Author: Wilhelm Dirks Issued: 12.05.2010

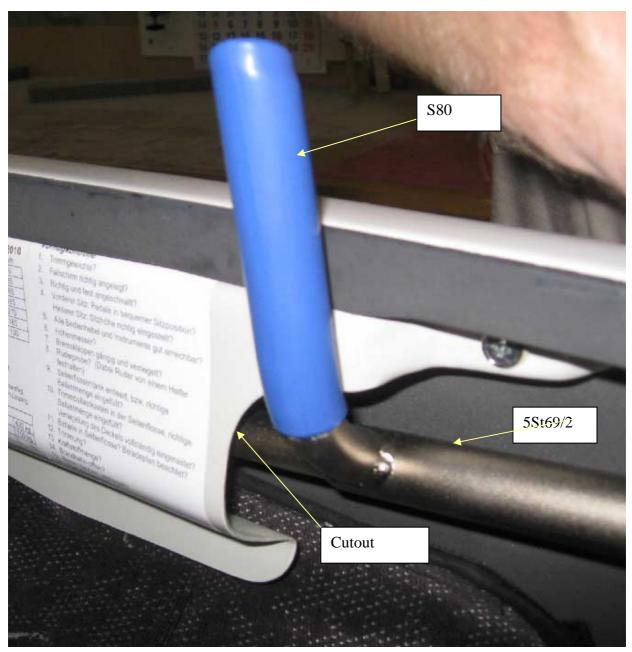
- 1. Remove side panels from the left side of the forward and rear cockpit.
- 2. Replace airbrake pushrod (Part 5St69) in the forward cockpit with pushrod with additional handle (Part 5St69/2), see also maintenance manual, diagram 3. Use new M6DIN985-8 zn self-locking nut and 1,5x12 DIN94 split pin.
- 3. Extend airbrakes completely, measure offset X between the stop 5St82/2 and 5St82/3 according to diagram 3 in maintenance manual.
- 4. Mark the position of the additional handle on the front side panel. Also mark the offset X and an additional 5 mm rearward from this position. The panel should be cut as in the photo below from this point.
- 5. Press S80 handgrips on both handles.
- 6. Reinstall forward and rear panels in the cockpit.
